Addendum No. 2
Wound Care Relocation
Kings Daughter's Medical Center
Russell, Kentucky

Addendum Issue Date: November 12, 2025

This Addendum is a modification of the Project Manual and Drawings dated September 9, 2025 for the construction of the above listed project. The modifications, revisions, and clarifications are as follows:

Issued by: Zachwieja Workman Architects/Consultants, Inc.

DRAWING
P2.1

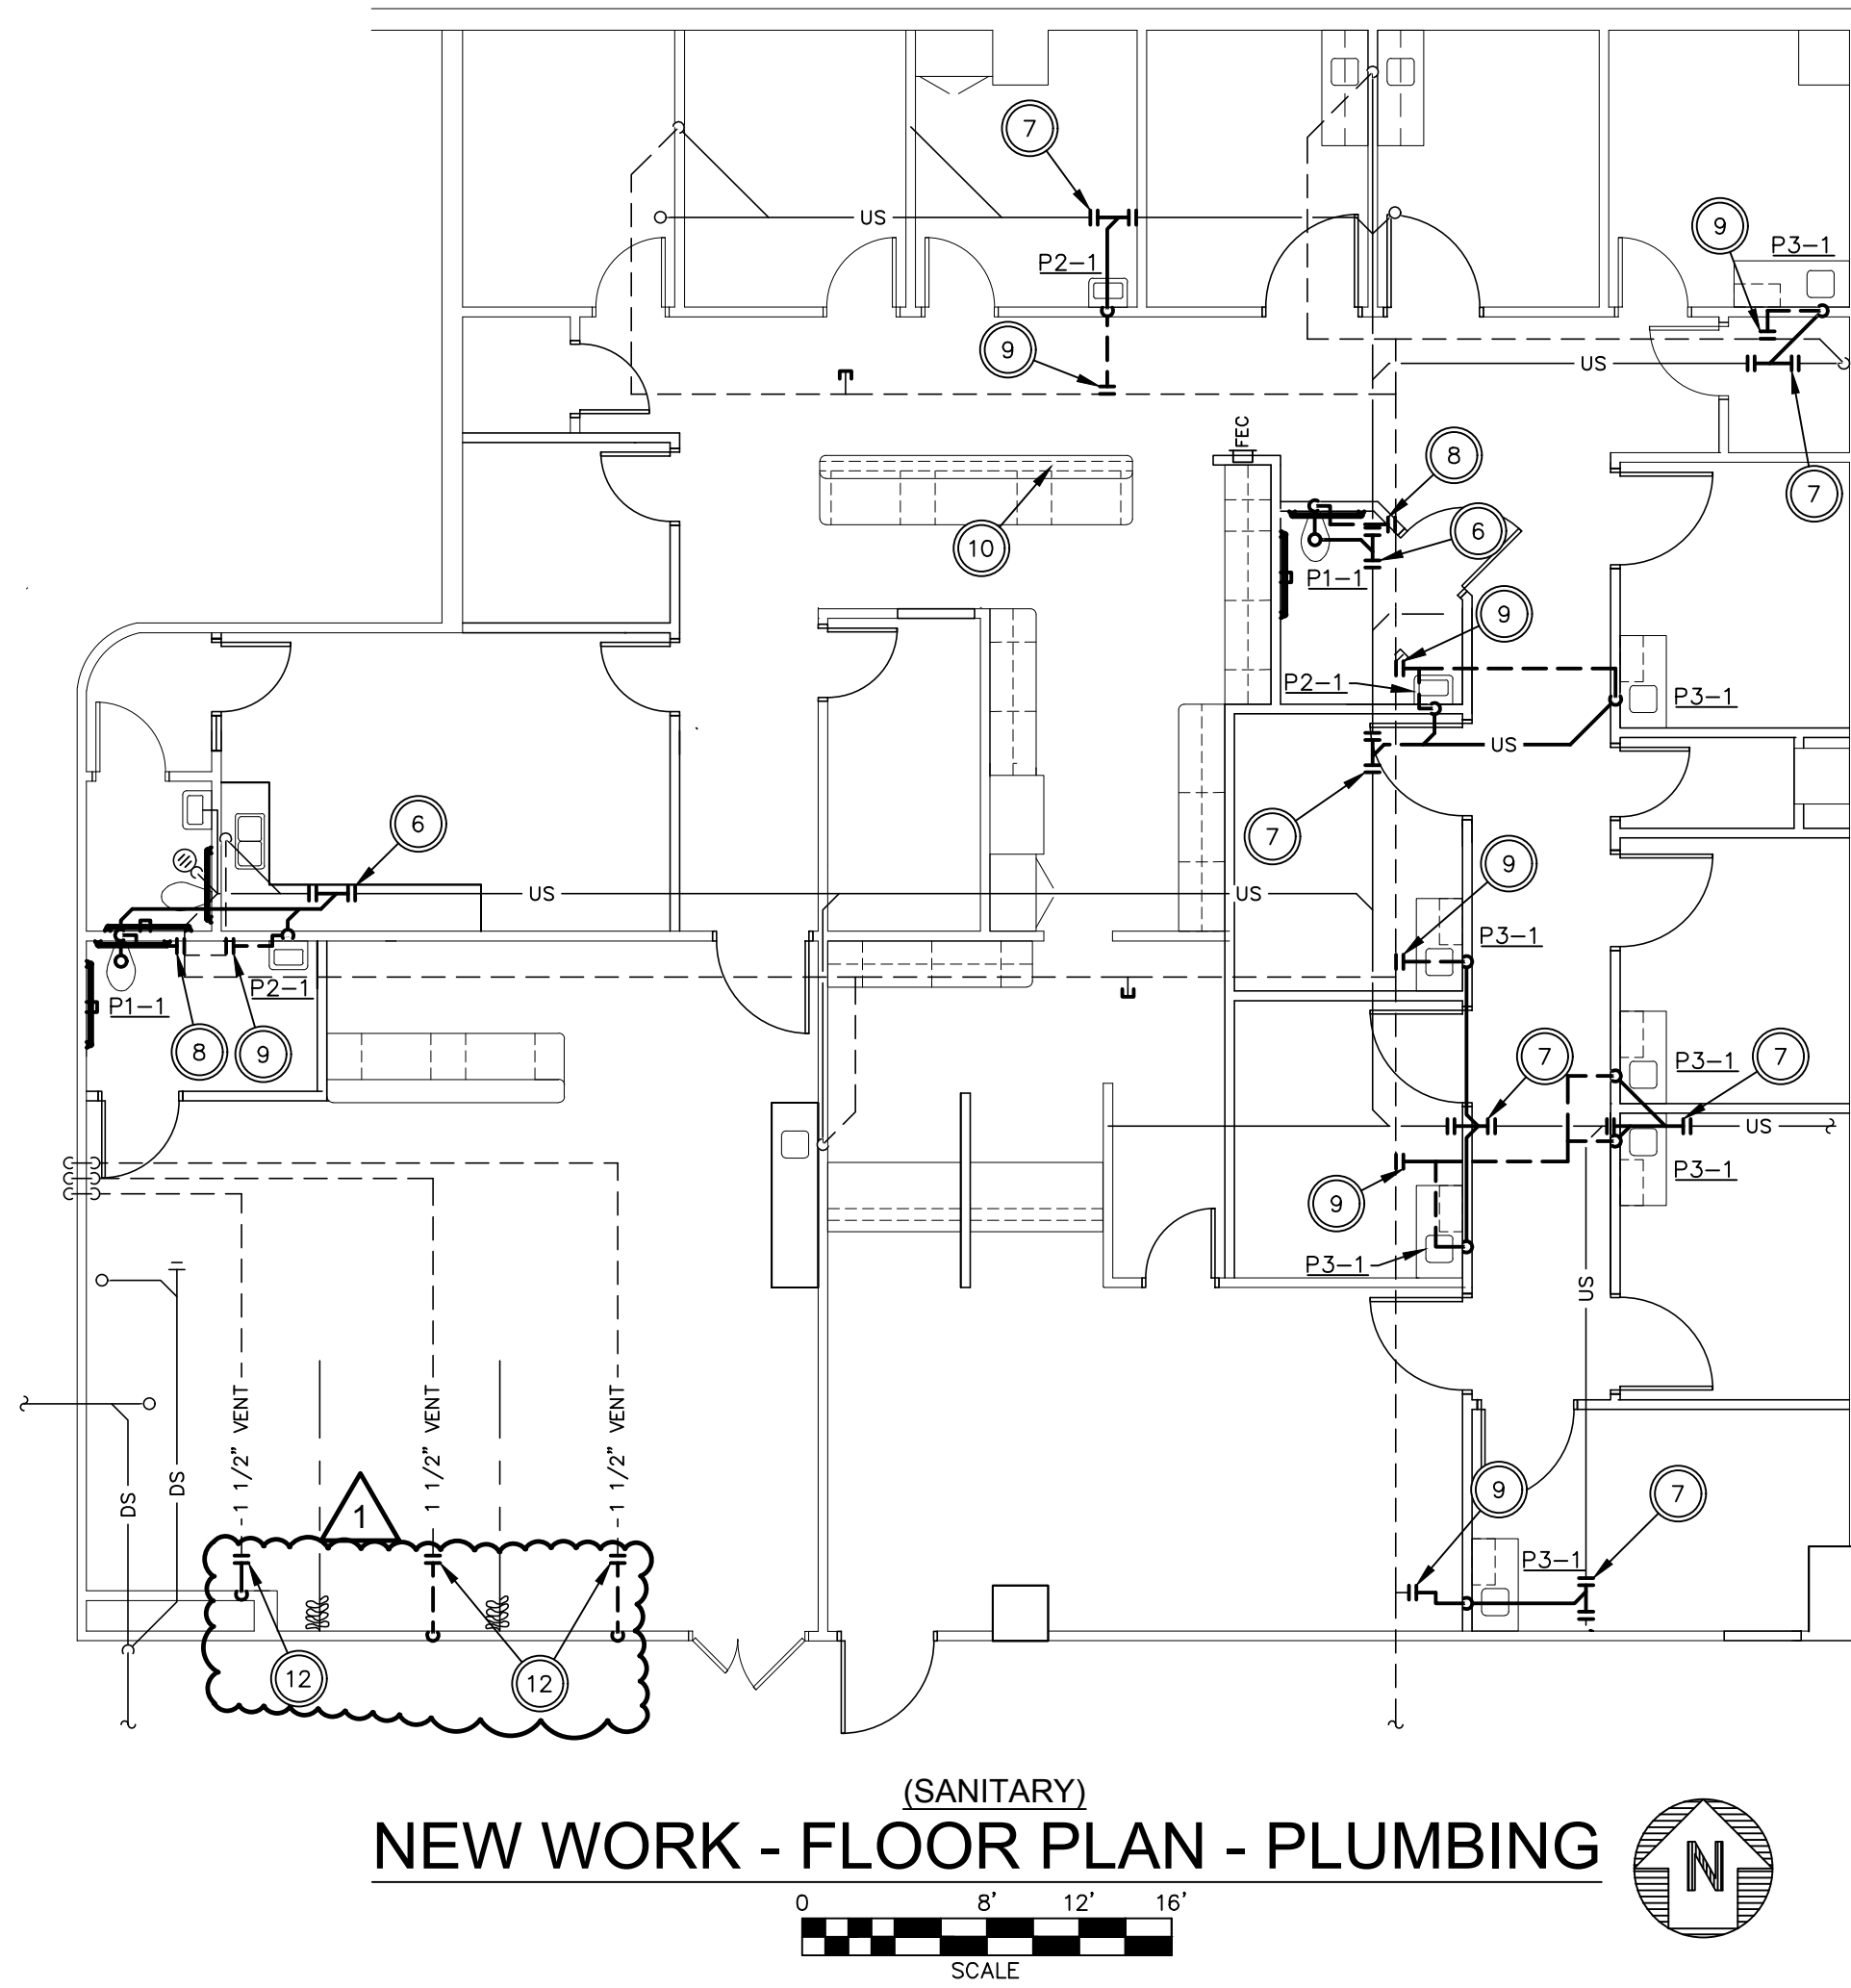
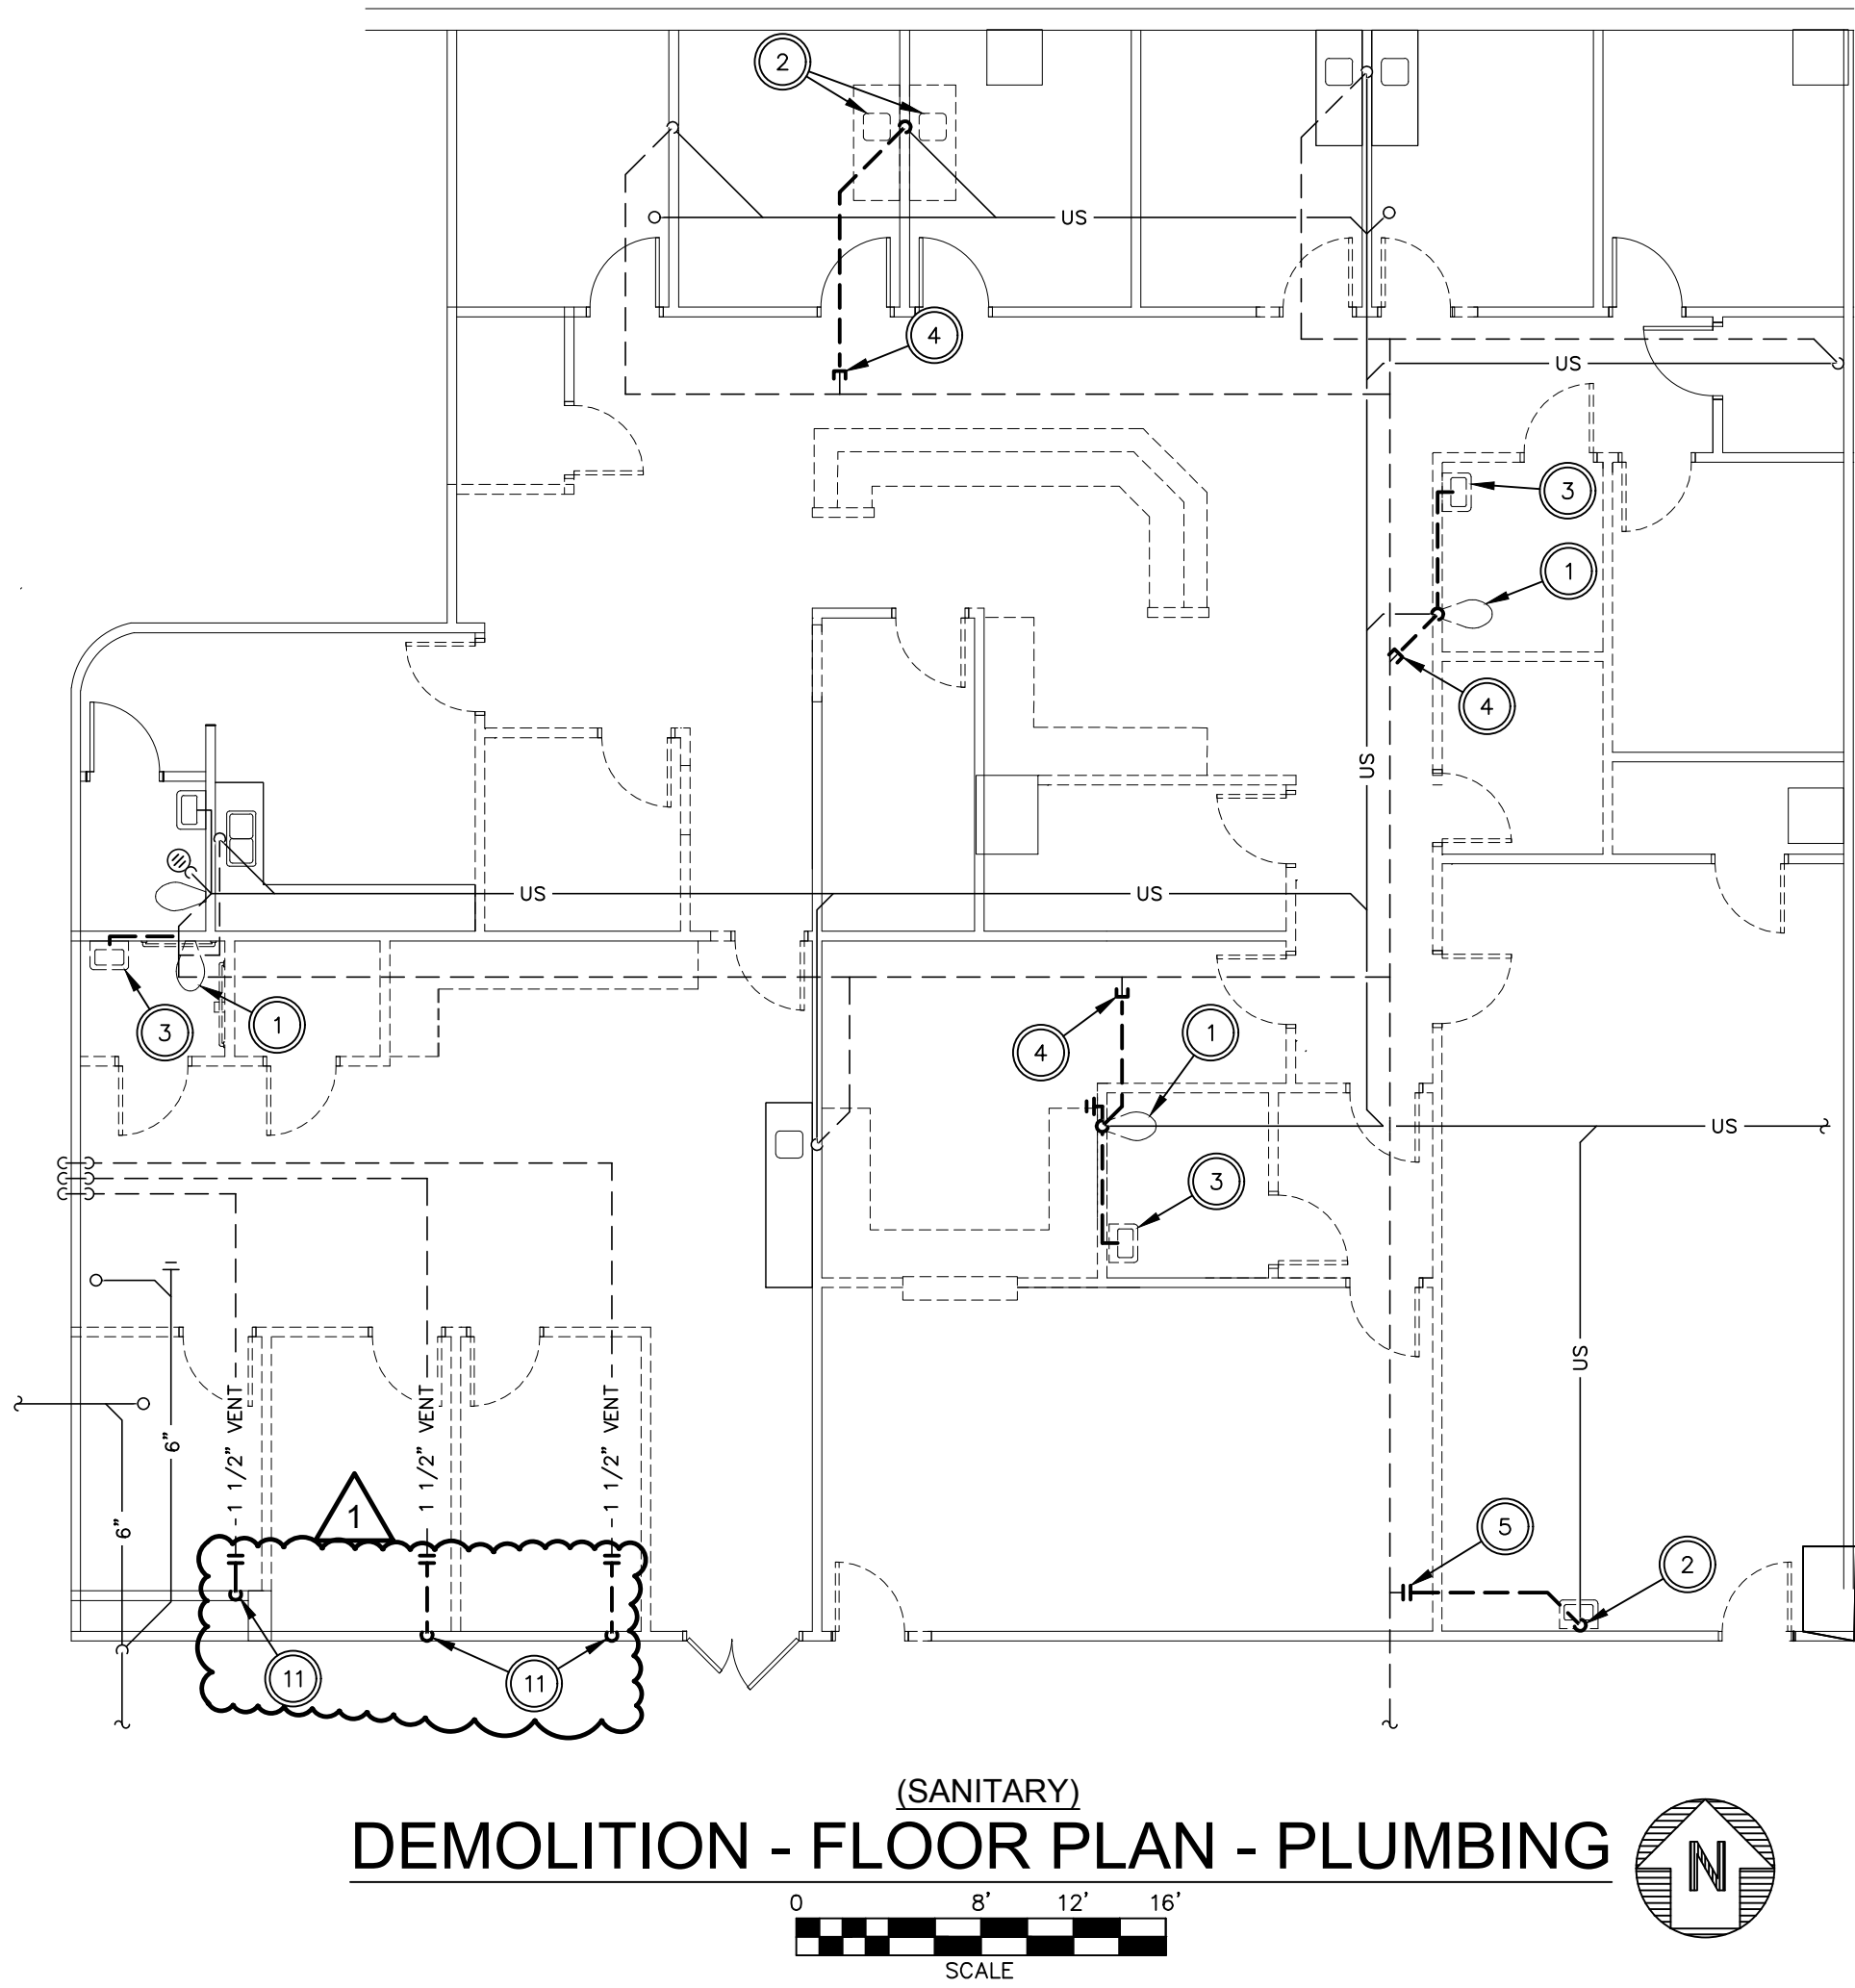
- Item 5: Drawing P1.1:
A. See attached drawing for addition of medical gas equipment schedules.
- Item 6: Drawing P2.1:
A. See attached drawing for addition of modifications to vent piping serving hyperbaric chambers.
